JINDABYNE POLICE STATION

BUILDING CODE OF AUSTRALIA VOL 1 2019 AMENDMENT 1 – ACCESS & DDA

Report prepared for	Group GSA L7 80 William St East Sydney NSW 2011 Attention: Oswaldo Marcelo & Janine Graves
Report prepared by	Metro Building Consultancy Suite 102, 12 Mount Street, North Sydney NSW 2060 Consultant: Sean Moore Drafted: Rebecca Kilty
Report reference	20250-JPS-Access-R02
Job number	20250
Date	09 February 2020

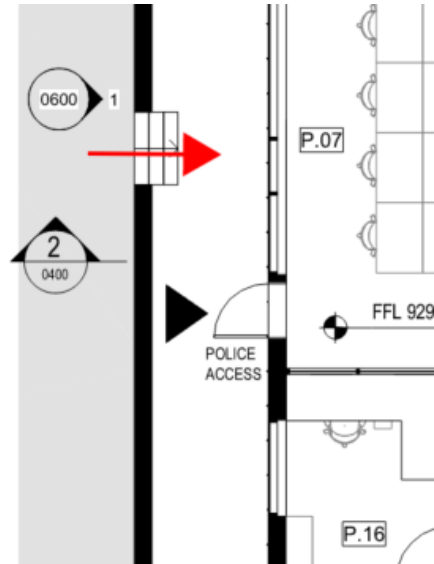
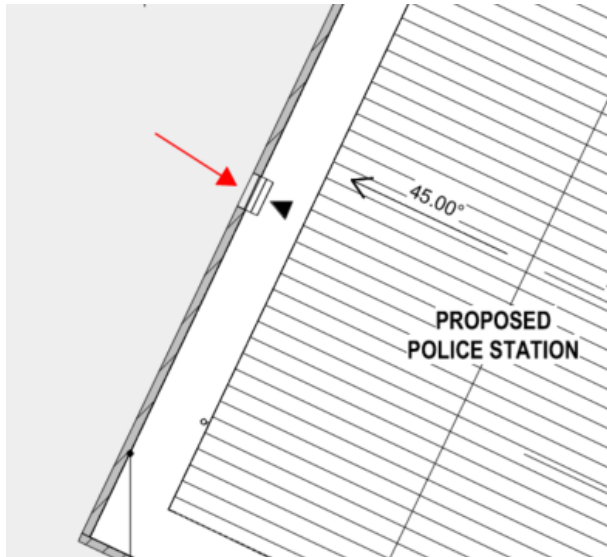
At this stage, the design has shown an accessible path of travel connecting the accommodation building to the proposed carport. It is still un-clear if the police station is to be accessible and how access is proposed between the buildings. See below.

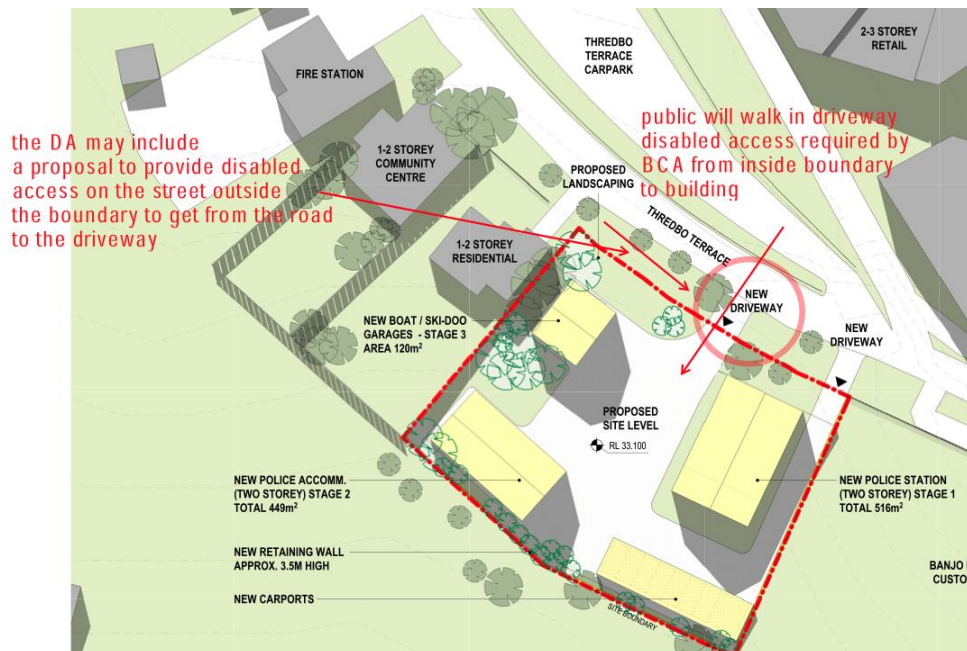
The BCA states that disabled access must be provided to the proposed buildings from the main points of a pedestrian entry at the allotment boundary. Further detail of the accessible path e.g. gradients, gate hardware, ramp & walkway compliance etc are required in the developed design drawings.

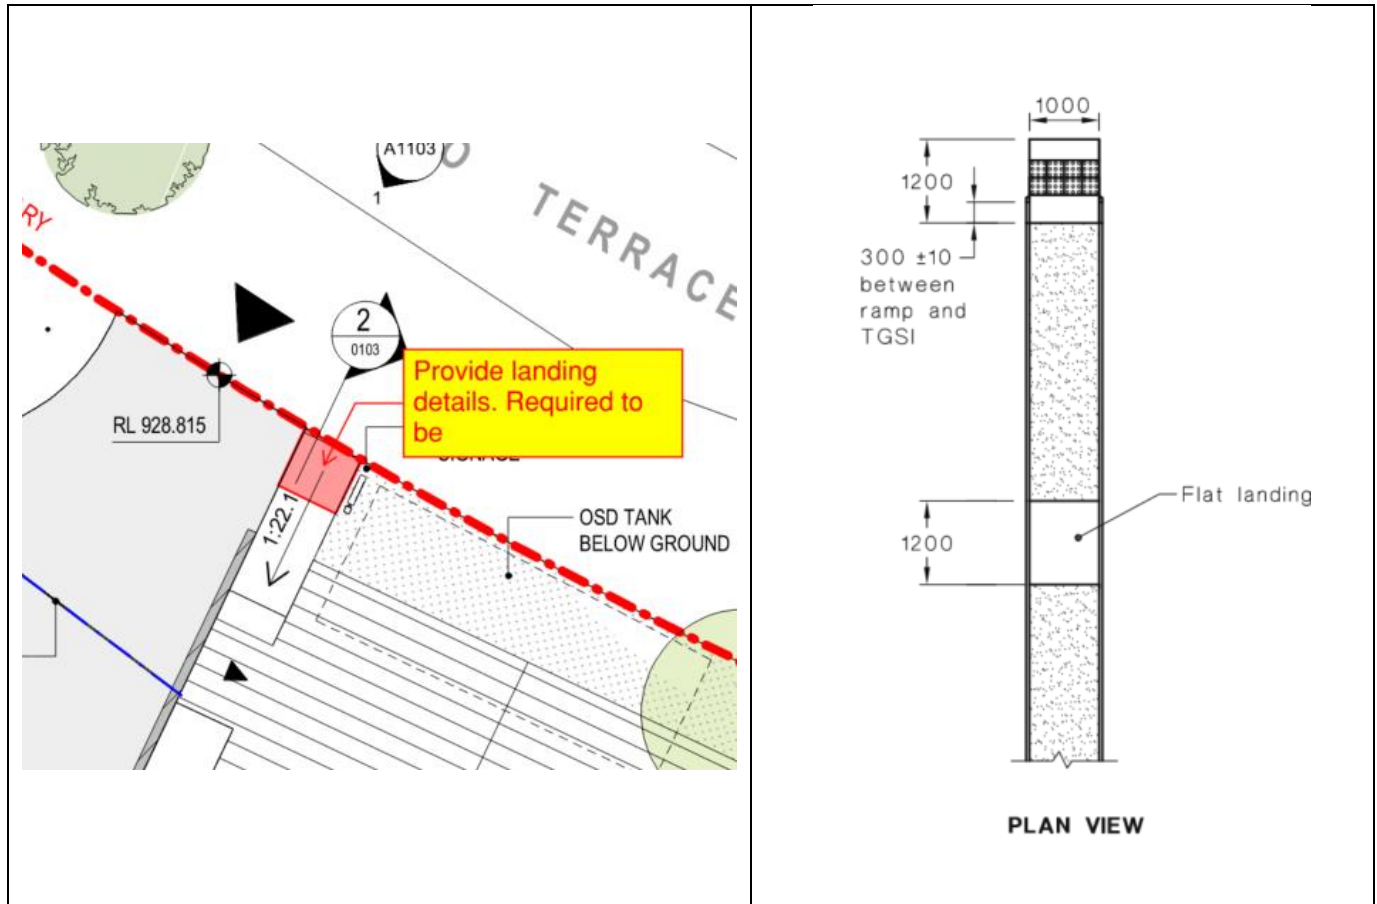
Detail of the accessible path of travel between the buildings are required in the developed design drawings. The entrance from the street to the proposed police station is required to have a landing. See details marked up below. If the walkway is shallower than 1:33 then no landings are required.

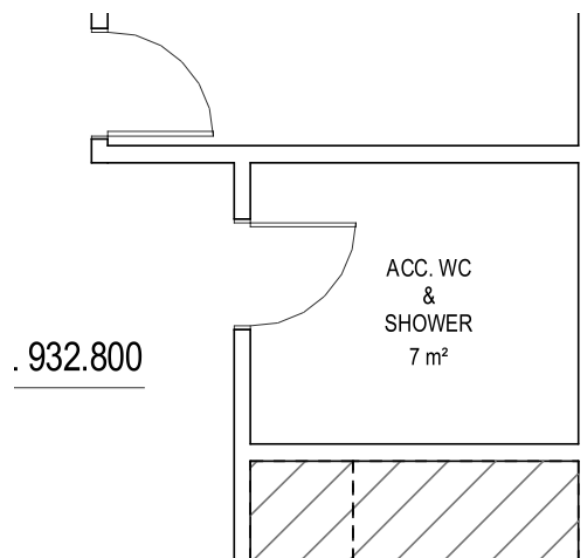
The Police Station building has been provided with an accessible toilet on level one, further design details are required to be provided in order to check compliance. The following should be taken into consideration when developing the design for the accessible toilet.

The design drawings are required to show further detail of the accessible shower and toilet in the police station building to ensure the required circulation space and fixture locations are compliant.
